Subject: Board of Water Supply (BWS) Comments to the Monitoring Well
Installation Work Plan, Red Hill Bulk Fuel Storage Facility

The BWS and its consultants have reviewed the document titled "Monitoring Well Installation Work Plan, Red Hill Bulk Fuel Storage Facility" (MWIWP) dated 29 April 2016 as discussed at the Tuesday 10 May 2016 meeting concerning the Administrative Order on Consent (AOC) work plans for Statement of Work (SOW) Sections 6 and 7. The BWS provides the following comments and recommendations to the draft MWIWP with the goal of ensuring that all work conducted under the final document will produce defensible scientific and engineering results needed to continue to protect our drinking water supplies.

Figure 1
 Geologic Cross-Section Through Halawa Valley from Wentworth (1942)

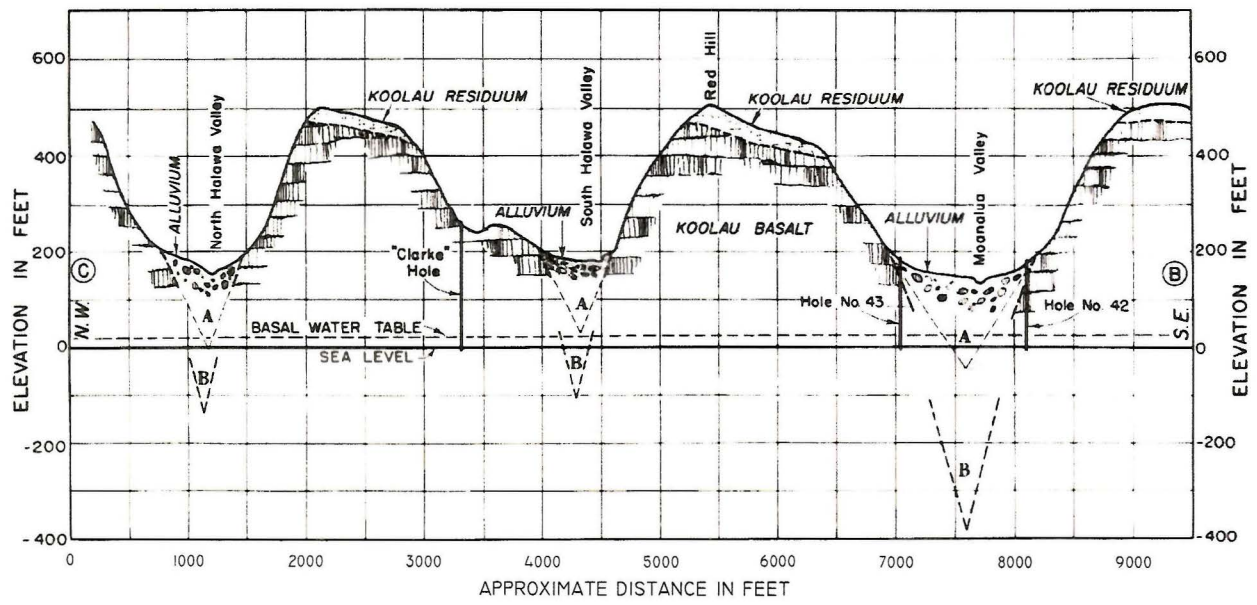
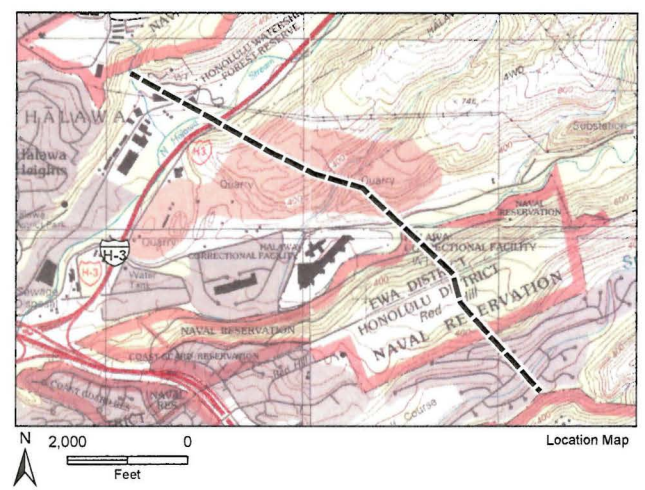
- 1) Figure 3 depictions of the assumed width and depth of the valley fill and saprolite in the North and South Halawa valleys do not take into account all available data; thus are misleading and could lead to incorrect choices for proposed well locations. Even if the authors of the MWIWP had relied only on Sherrod et al. (2007) or Stearns (1939), the depicted widths of Halawa valley fills are exaggerated by at least 50% beyond those sources. A brief physical visit to South Halawa valley will reveal that deep valley fill (greater than 50 feet in thickness) is confined only to the eastern branch of South Halawa Stream and does not extend to the western branch. The depicted depths of valley fill and saprolite also appear exaggerated and Figure 3 should be revised to reflect Plate 1 of Izuka (1992) and Figure 25 in Wentworth (1942). The enclosed Figure 1 to this letter reproduces the relevant part of Wentworth's Figure 25, which shows two end members, A and B, for the depth of valley fill in the two valleys. Only one deep well (CWRM Deep Monitoring Well HDMW2253-03) has been installed in this area of Halawa valley since Wentworth (1942) and this well appears to intersect the eastern part of the South Halawa valley fill.

Figure 2
Suggested
Alternative Location
for RHMW09

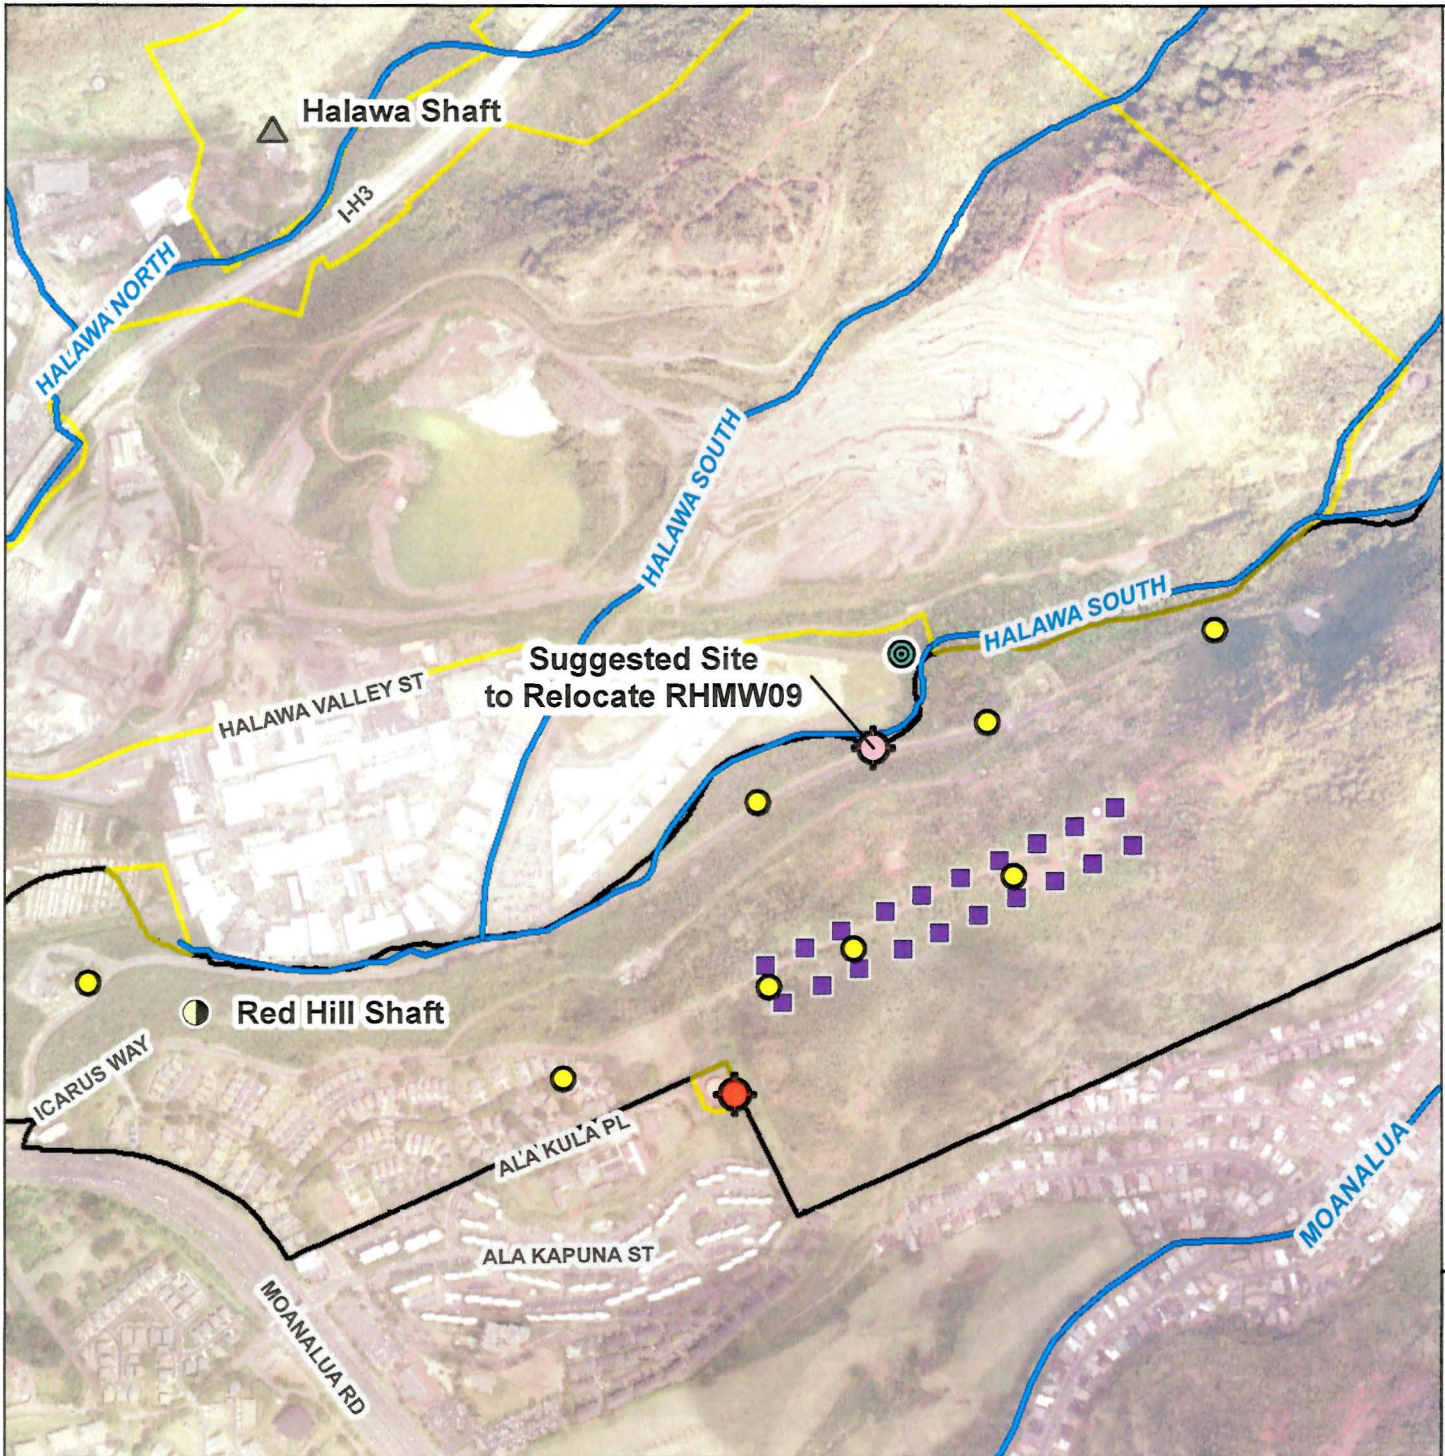
- 2) The proposed monitoring well Red Hill Monitoring Well (RHMW) 09 location is in very close proximity to a monitoring well being planned to be installed by the BWS. We recommend re-locating RHMW09 to the south side of Halawa Valley, along South Halawa stream, within the Red Hill Bulk Fuel facility boundary, such as the location shown in the enclosed Figure 2.
